Re: ADDENDUM #4
Contract No.: DB1802
County: Polk

US-64 (SR-40) over Ocoee River Bridge

CONTRACT NUMBER: DB1802

Addendum #4 September 9, 2019

PILASTER WITH OCOEE LOGOMARK

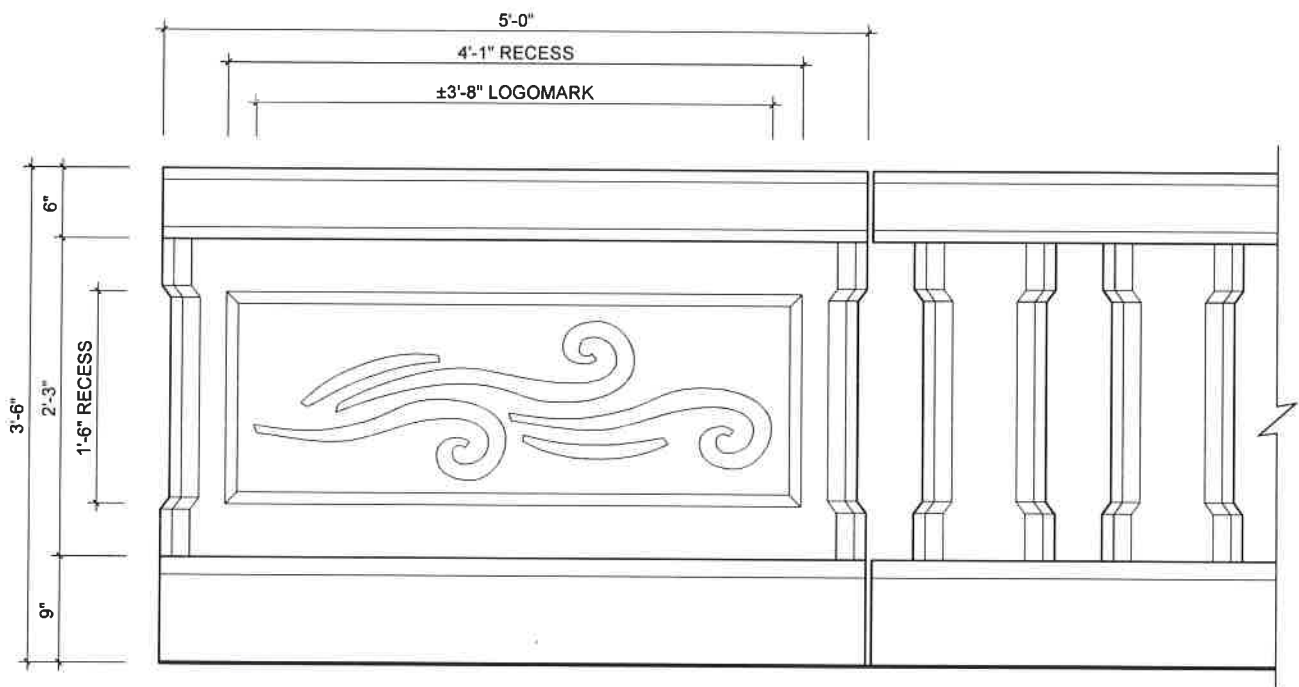
The bridge rail shall be a concrete open rail crash tested to meet a 50-mph design speed. It shall include the Tri-Star emblem as shown on the TDOT Standard Drawing STD-8-6. *The bridge rail shall also include an intermediate post over each pier with an Ocoee logo recess on both faces of the post (see the Reference Material on the project website for a rendering of the intermediate post and the Ocoee logo recess detail). The one-inch deep recess shall be the same blue (including clear coat) as on the Tri-Star State Emblem (see Standard Drawing STD-8-6), and the Ocoee logo shall be the same white (including clear coat) as the Tri-Star State Emblem.* The bridge preliminary provided by TDOT shows standard rail STD-11-4 (included in Reference Material located on the project website) which can be used for speeds of 50 mph when a MASH TL-3 rated guardrail transition is used. The Design-Builder may submit an ATC for an alternative open concrete rail for approval. An open concrete rail is required for aesthetics to provide a view of the river through the rail.
